ITS3 activities in Bari

BBM6 Thermal Test Assembly

5) SUPPORT STRUCTURE

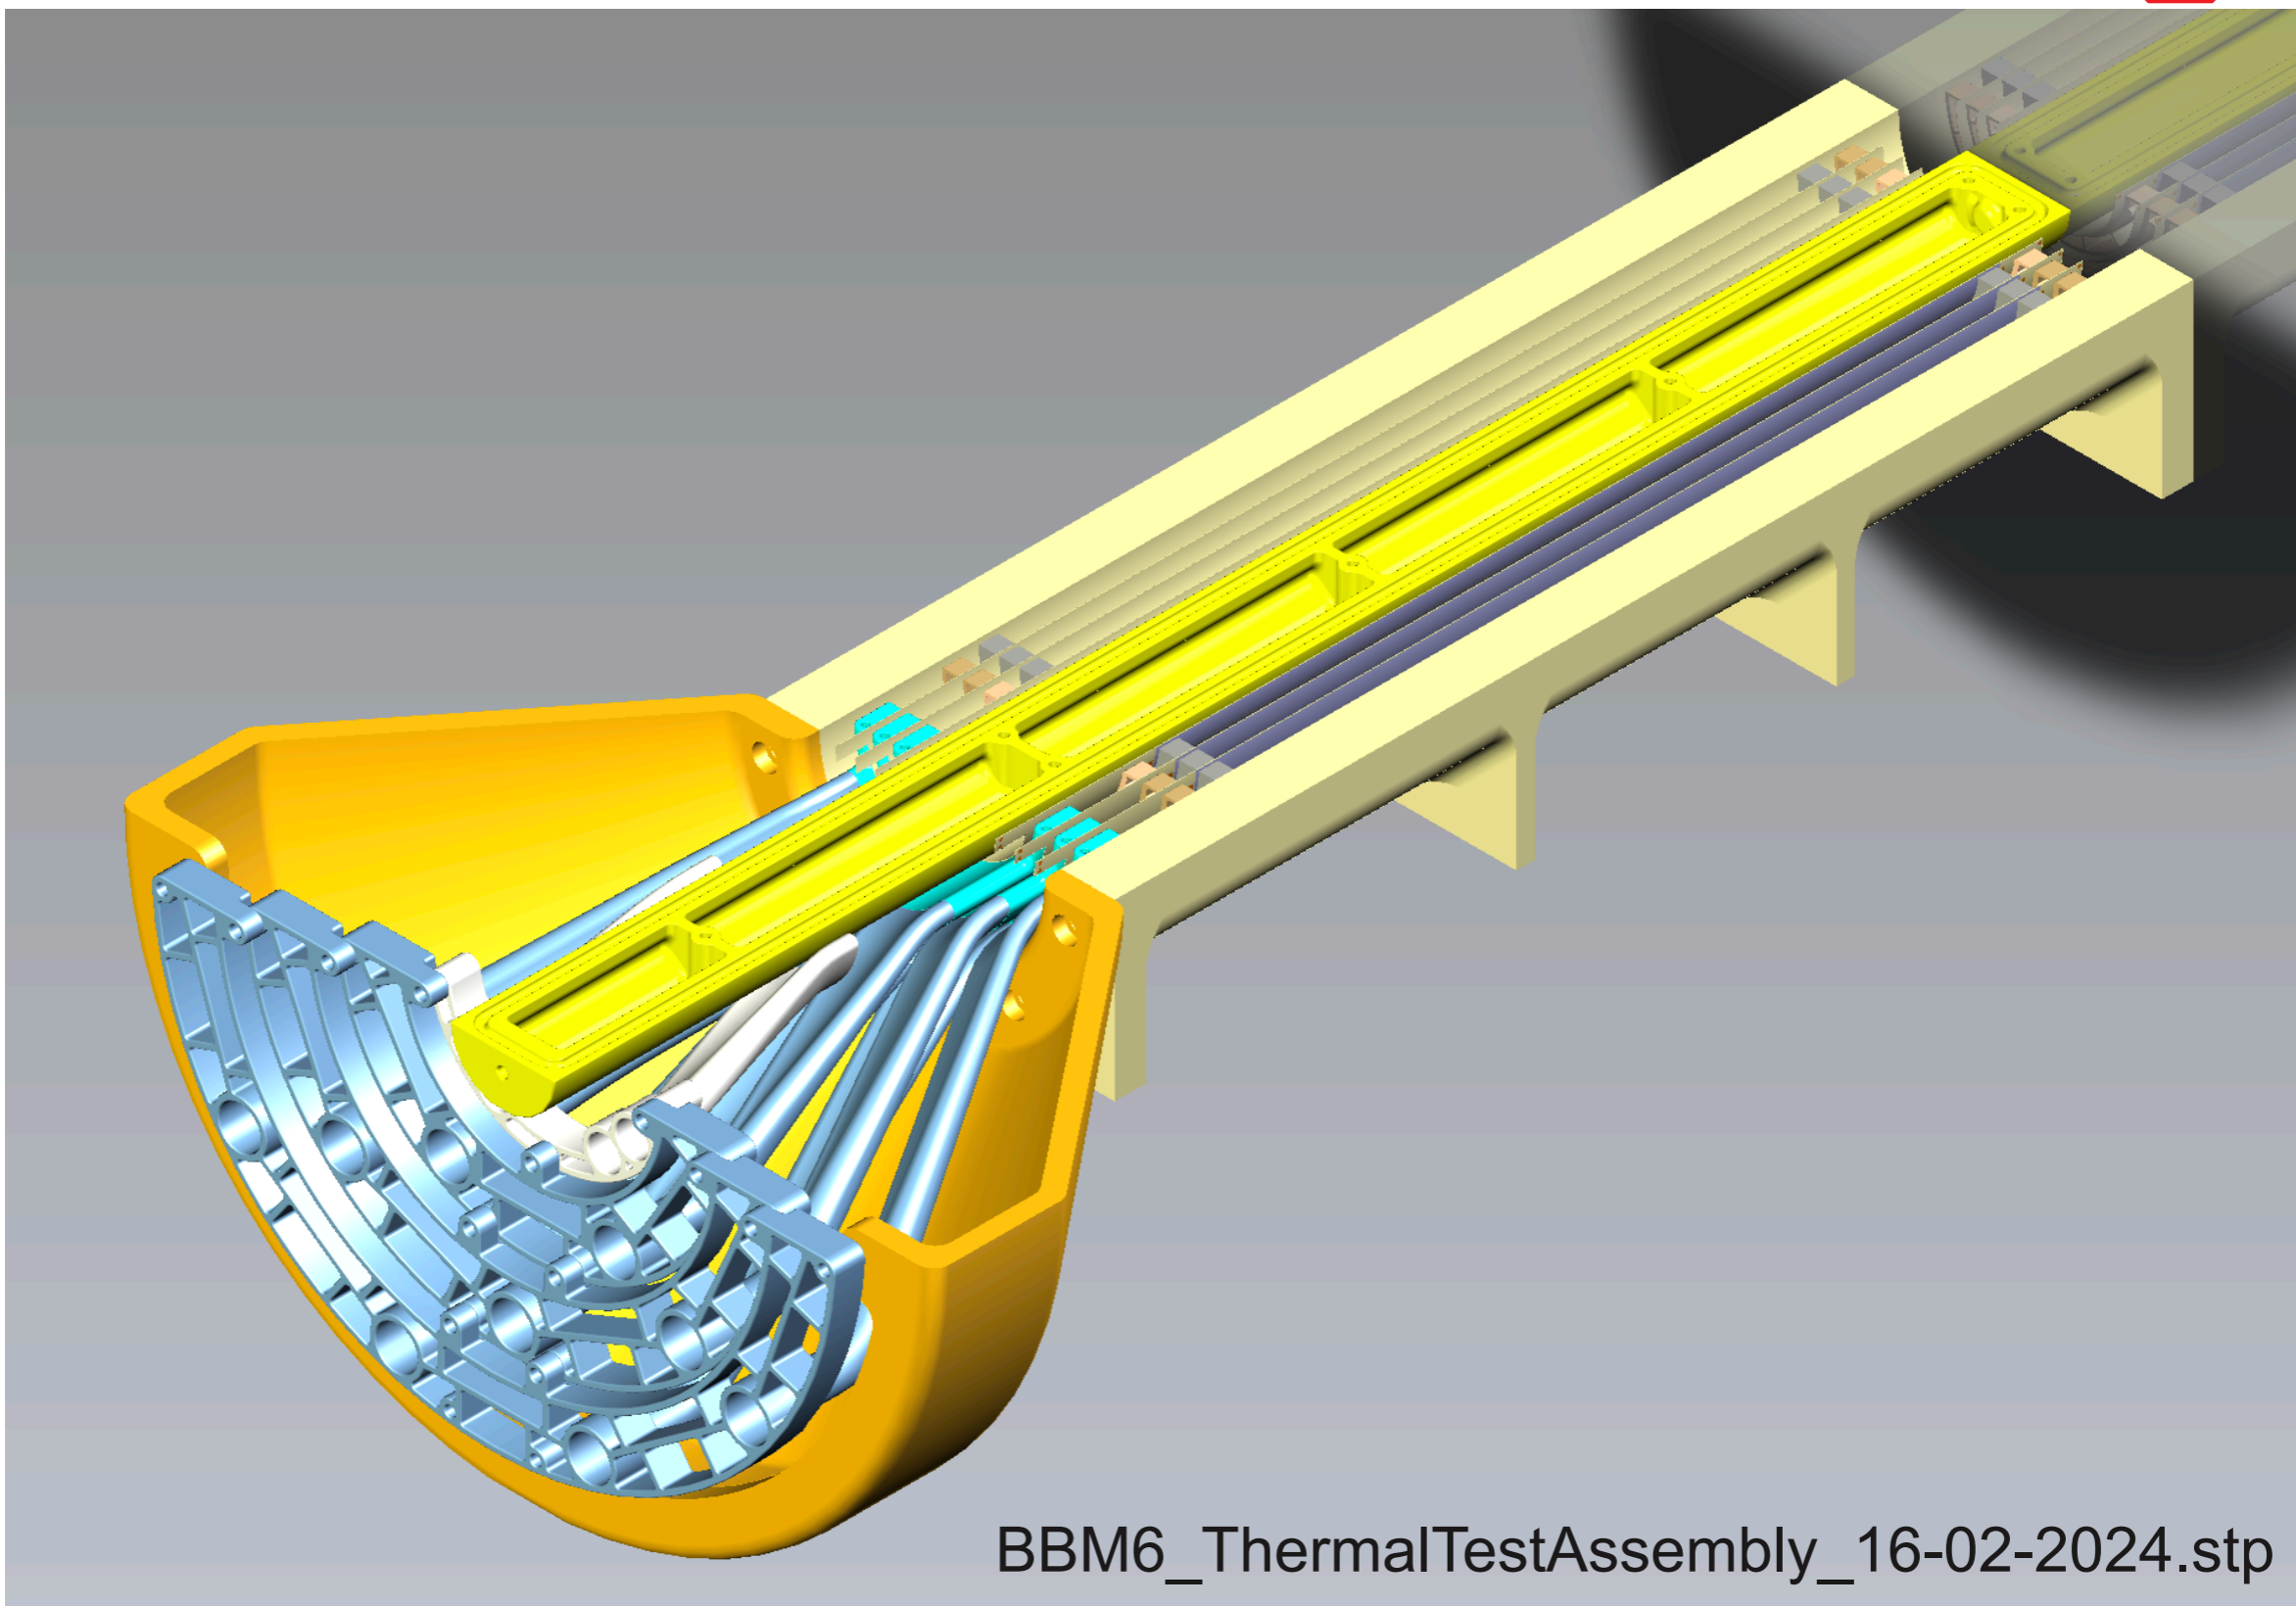
Is this solution compatible with wind tunnel?

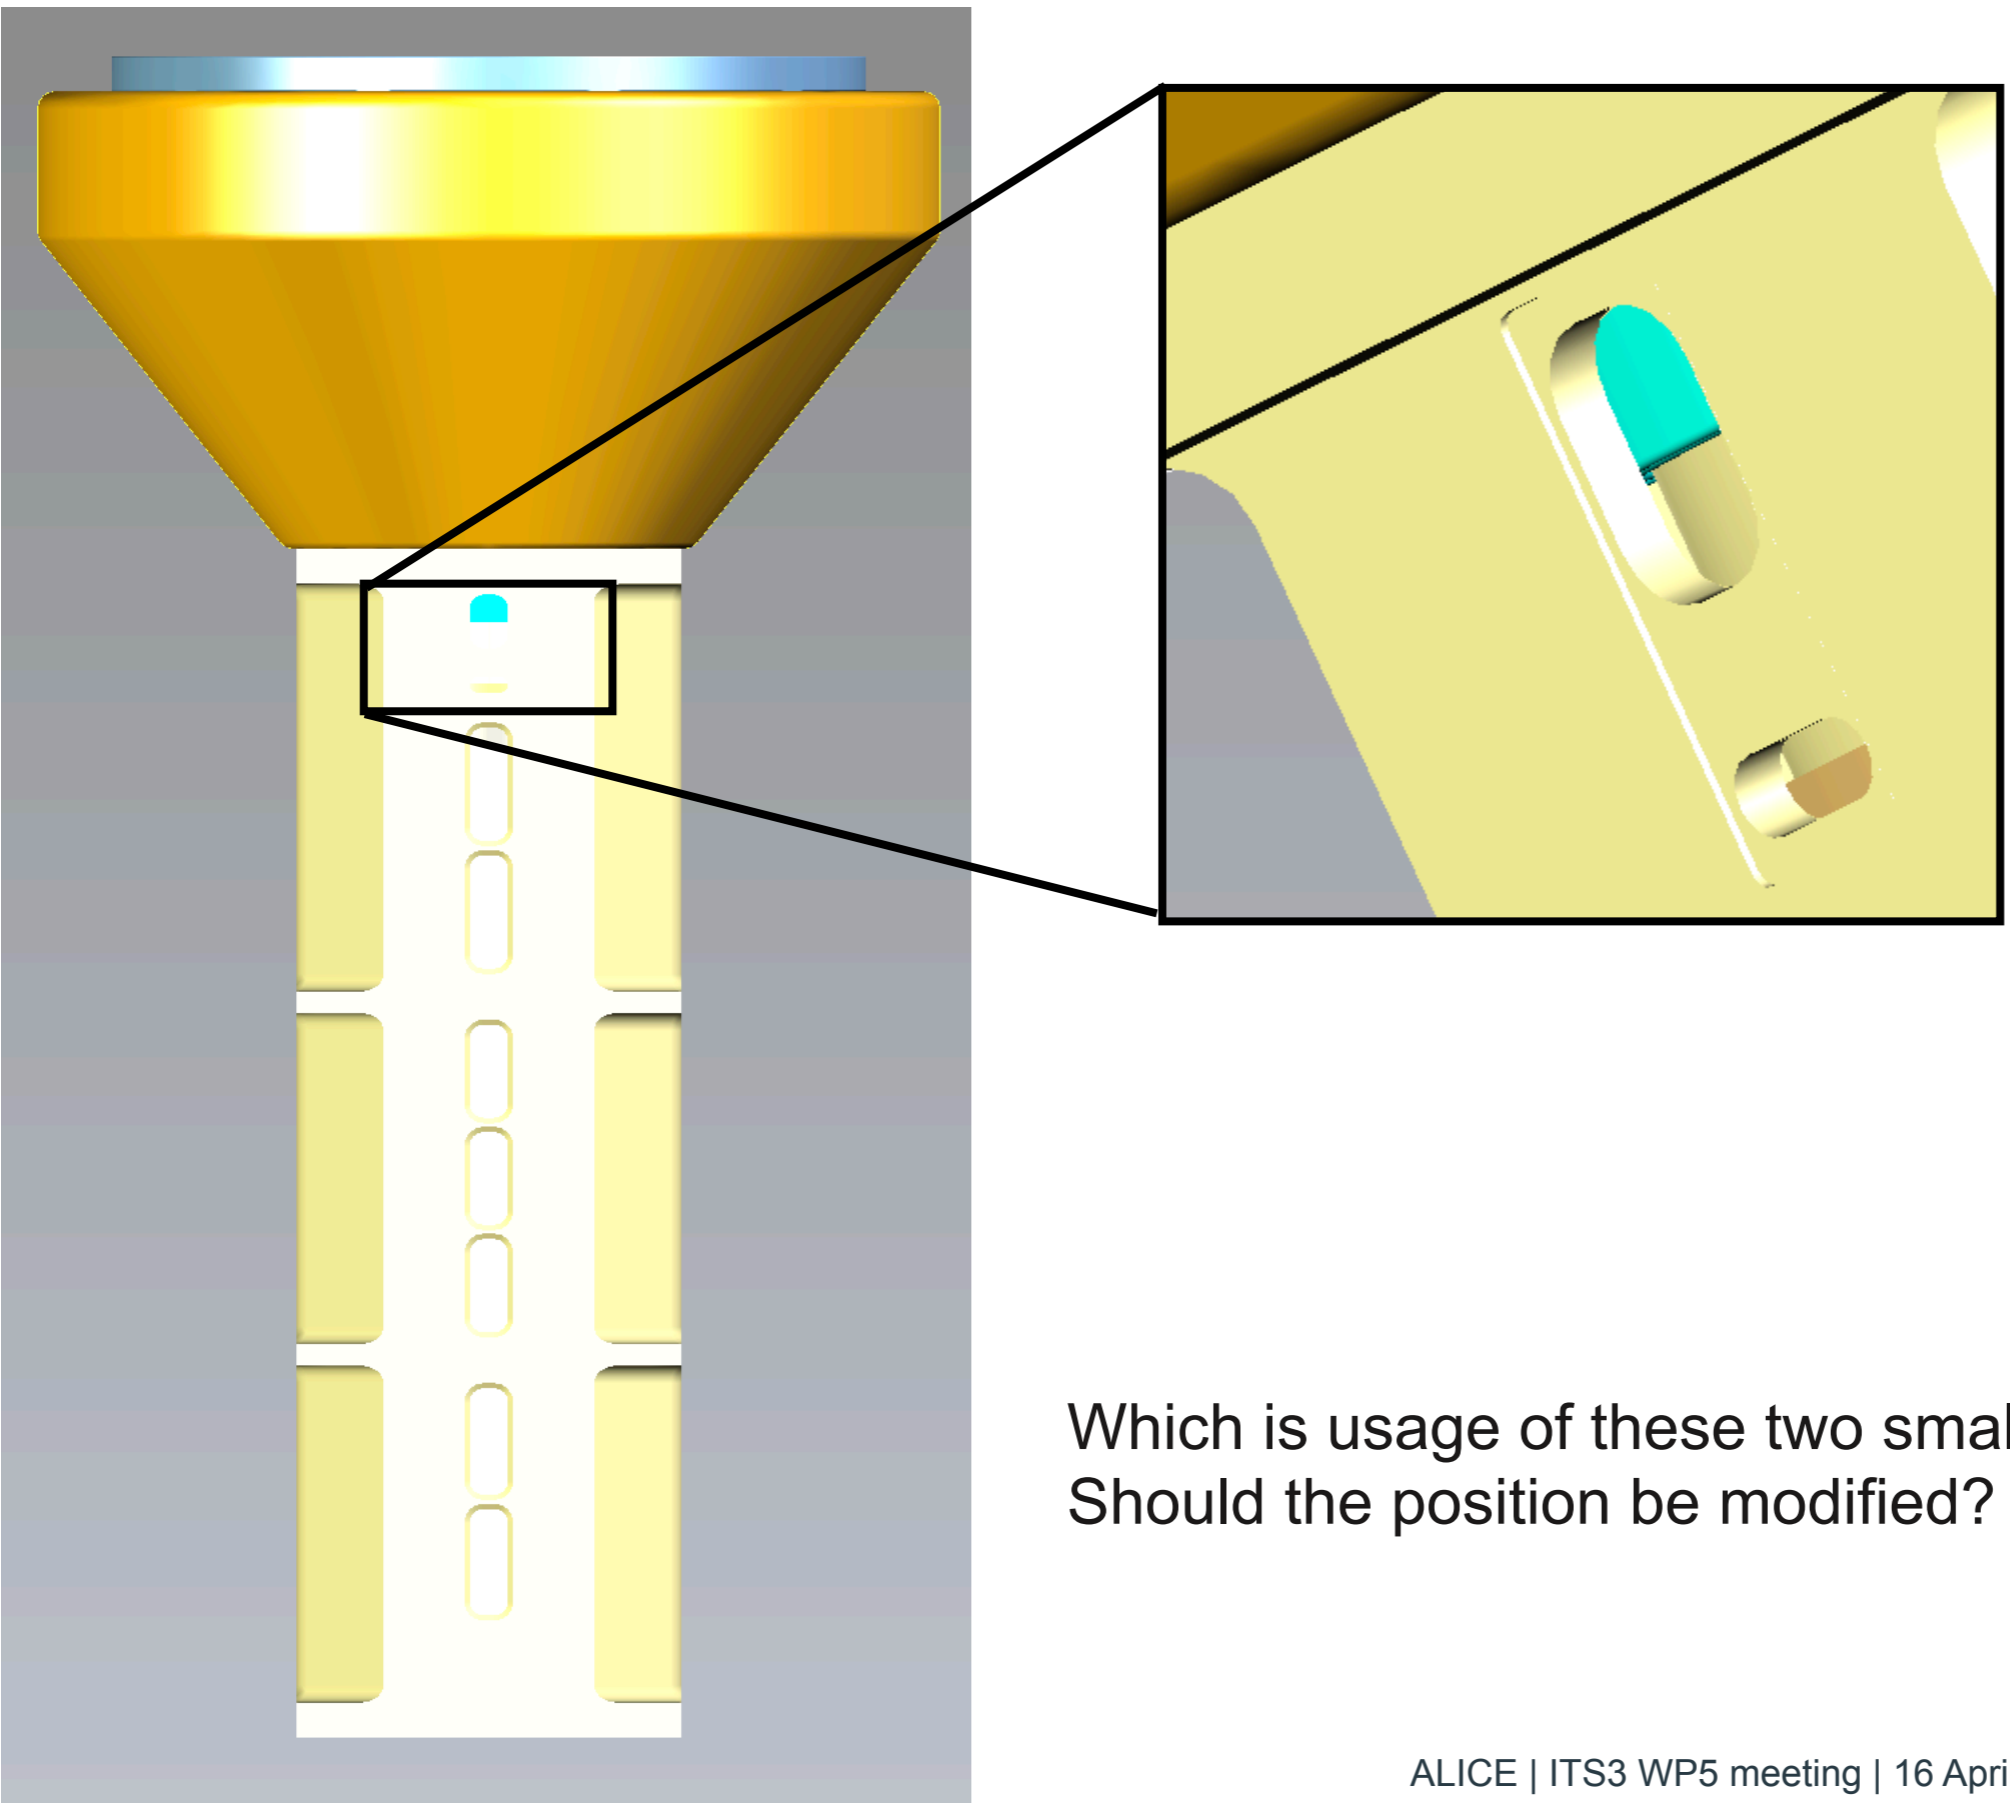
- Dimensions and positions of the big openings have been respected.
- Position of the first one interfere with the below half-ring.
- True also for the small window above interfering with service half-ring.

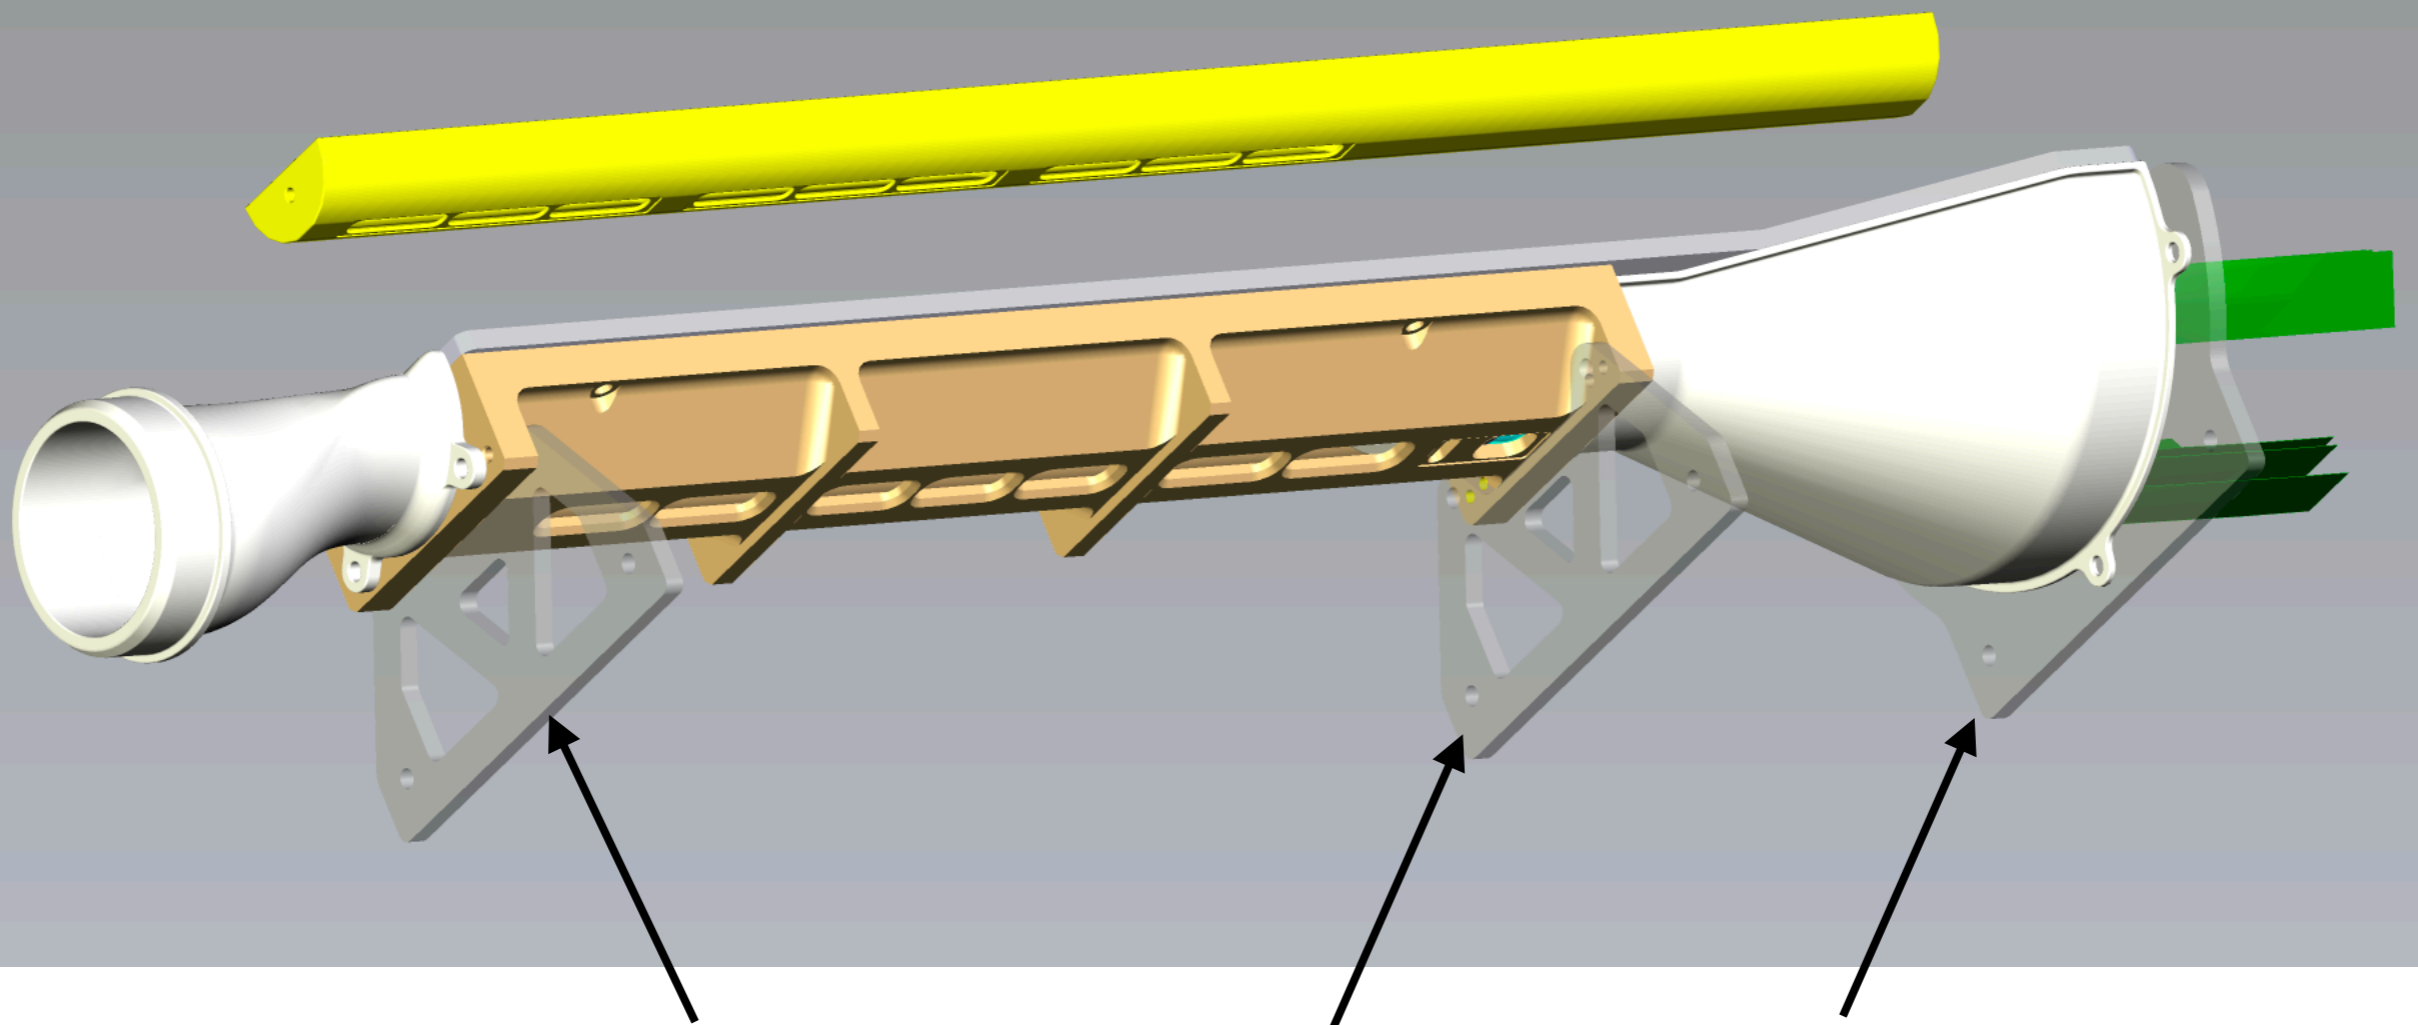
Which is usage of these two smaller windows?
Should the position be modified?
